SOUTHWEST BIKEPATH CULVERT REPLACEMENT AT WAITE CIRCLE - 2019

CITY OF MADISON, WI

CITY PROJECT NO. 8466

ADDENDUM 1
8/29/19
CHANGED ENTIRE
DRAWING

**CIVIL
 RAILING DETAIL**

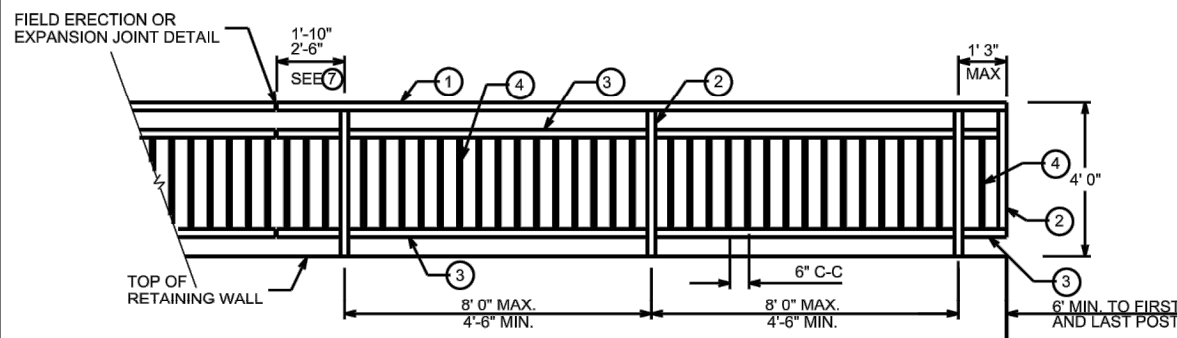
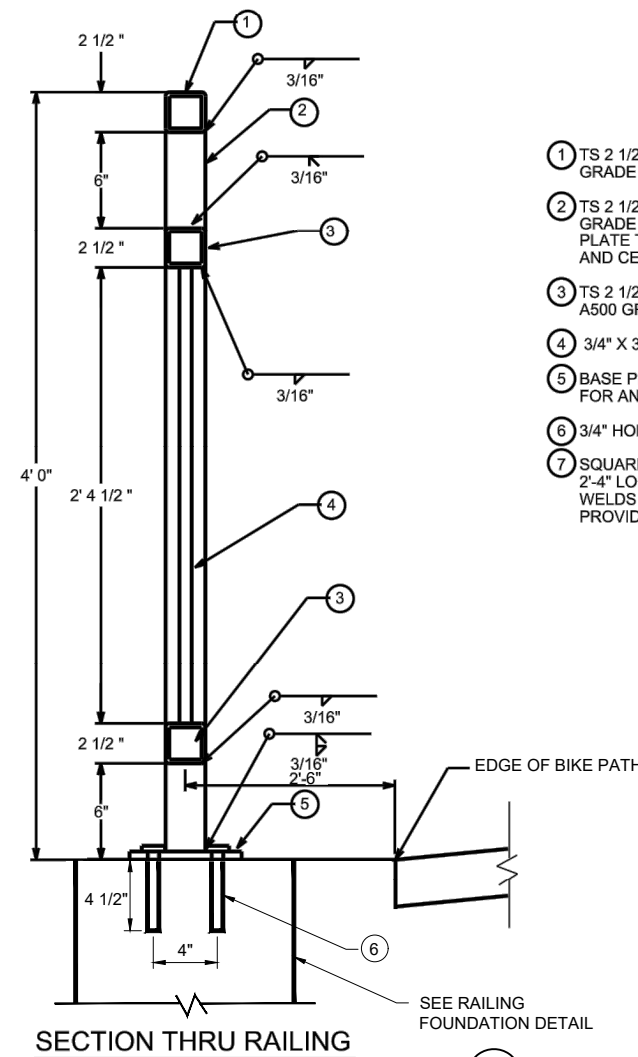
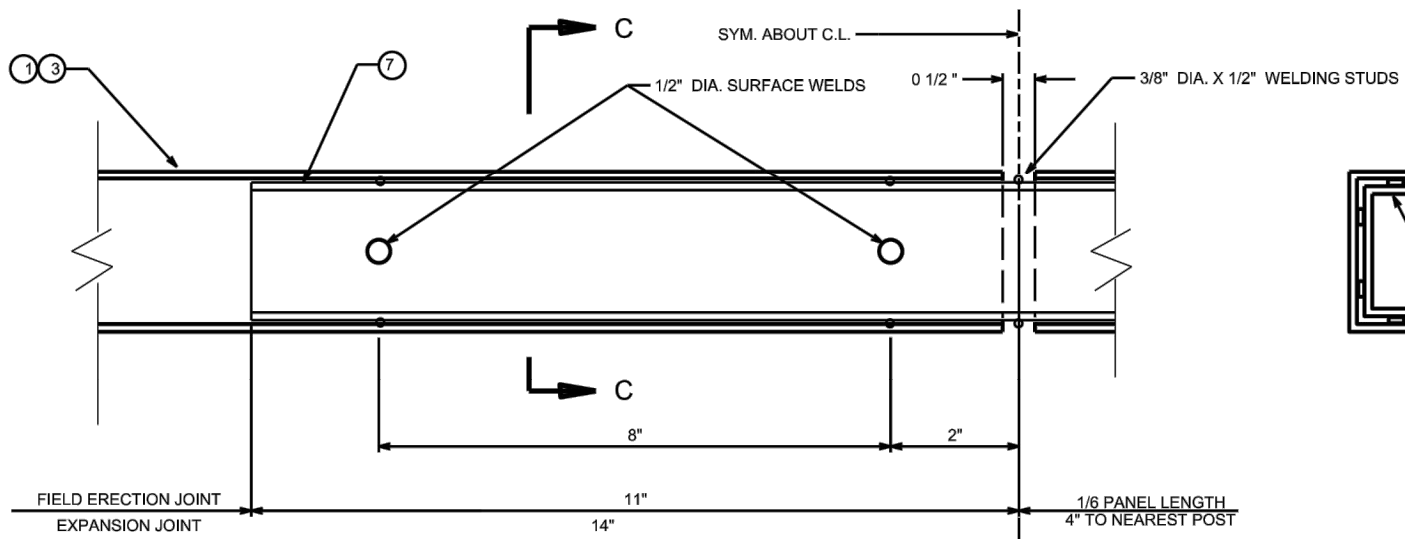
ADDENDUM 1
 CHANGED DETAIL
 NUMBER AND
 DRAWING NUMBER
